Groundwater Transfer Review Summary Form

Transfer/PA # T- 14712

Application: T-14712

Applicant Name: Moore Sisters Farm, LLC

Well Location Map

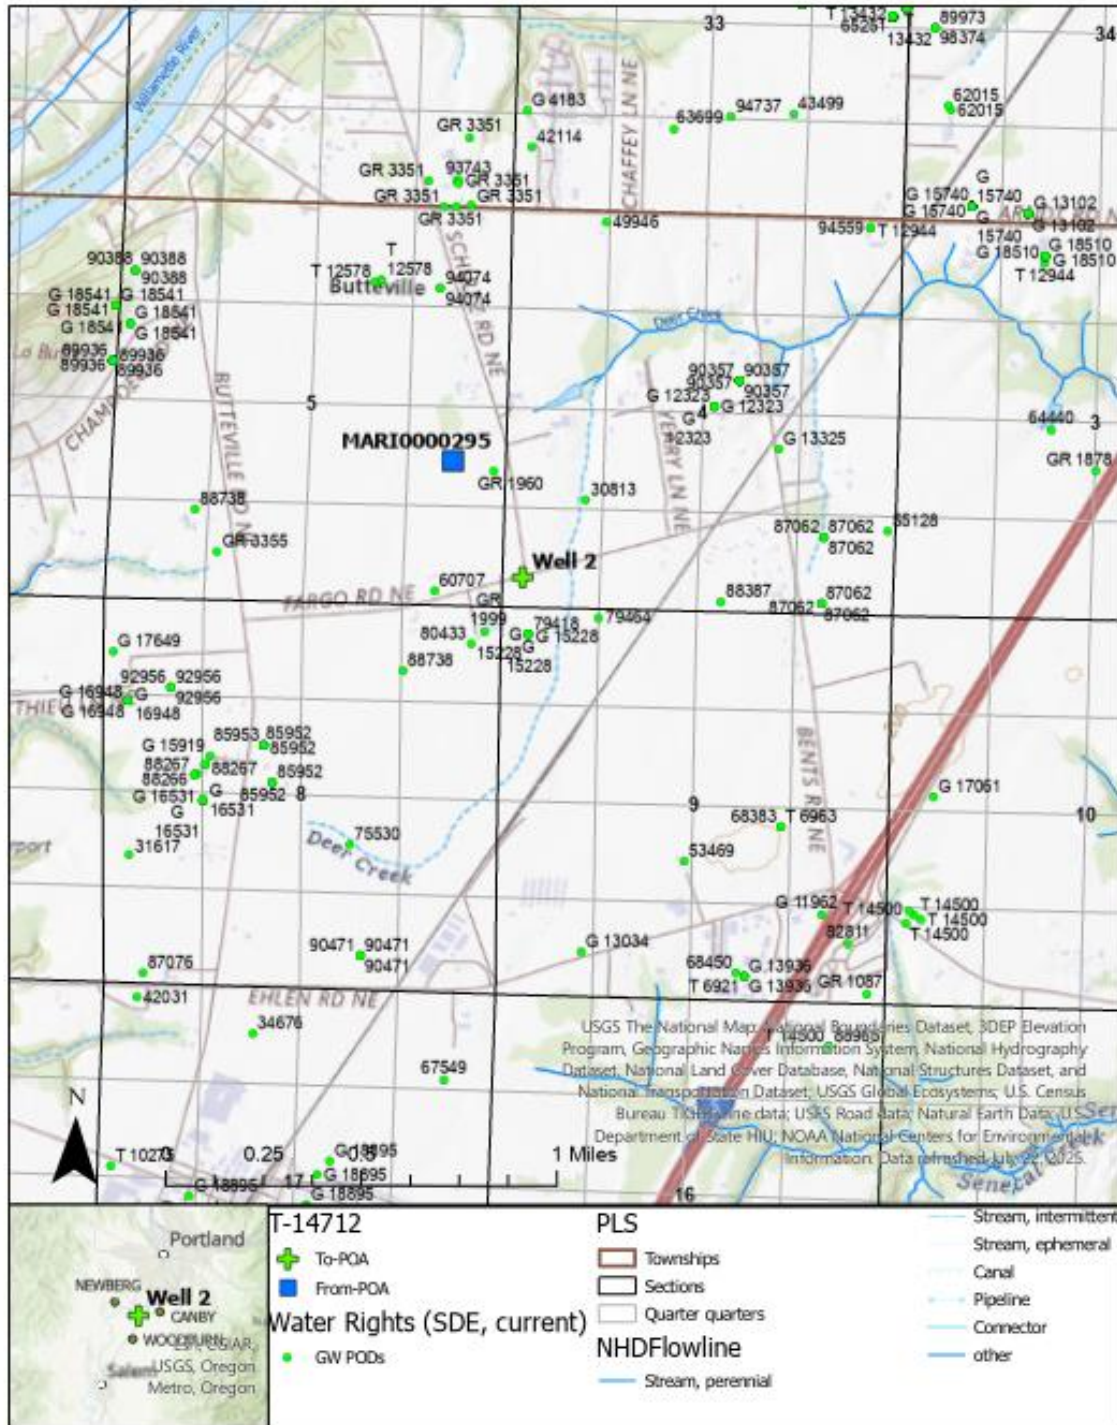
5. a) Will this proposed change, at its maximum allowed rate of use, likely result in an increase in interference with **another ground water right**?
☒ Yes ☐ No Comments: The proposed To-POA Well 2 will be closer to authorized POAs associated with Permit G-15228, GR-1999 and Certificates 60707, 79418 and 80433 located to the south of the authorized From-POA Well 1. MARI 53703 is the closest authorized POA for Permit G-15228 and Certificate 79418 and is located ~800 feet south of the proposed To-POA while the From-POA (MARI 295) is ~2,500 feet north of MARI 53703. Moving use closer to MARI 53703 is likely to result in an increase in interference with that well.

6. a) Will this proposed change, at its maximum allowed rate of use, likely result in an increase in interference with **another surface water source**?
☒ Yes ☐ No Comments: The proposed To-POA is ~7,100 feet north-northwest of Senecal Creek whereas the From-POA is ~8,800 feet north-northwest of Senecal Creek. The reduction in distance between the To-POA and Senecal Creek compared to the From-POA will likely result in an increase in interference with Senecal Creek.

Well Interference Analysis (Theis, 1935)

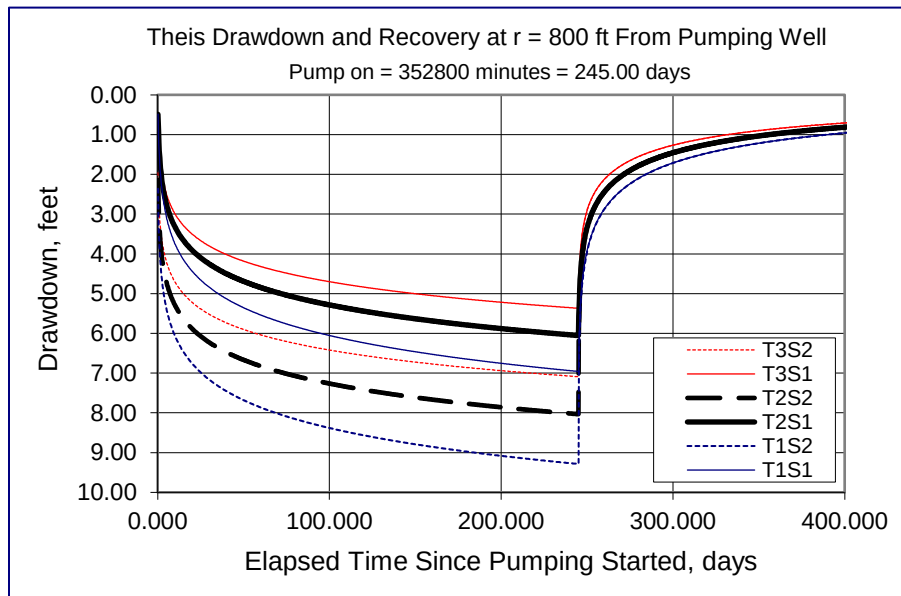
- b) If yes, would this proposed change, at its maximum allowed rate of use, likely result in another groundwater right not receiving the water to which it is legally entitled?
☐ Yes ☒ No If yes, explain: The maximum allowable rate of use from proposed To-POA Well 2 would be ~0.5 cfs ($[1.27 \text{ cfs} / 154.64 \text{ Acres}] * 60.65 \text{ Acres} = 0.50 \text{ cfs}$). Potential interference with MARI 53703 due to the proposed change was analyzed using the Theis (1935) solution for drawdown in a confined aquifer (see attached Well Interference Analysis). Results of the analysis indicate that the proposed change is unlikely to injure MARI 53703 or similar neighboring groundwater rights.

Radial distance, $r = 530$ ft [approximate distance from To-POA (MARI 68707) to MARI 71663]

Pumping time, $t_{\text{pump}} = 245$ days [irrigation season]

Pumping rate, $Q = 0.5$ cfs [max rate for proposed Well 2]

Transmissivity: $T1 = 3,400$ ft²/day; $T2 = 4,000$ ft²/day; $T3 = 4,600$ ft²/day [pumping test reports]

Storativity: $S1 = 0.003$; $S2 = 0.0003$ [Conlon et al., 2005]
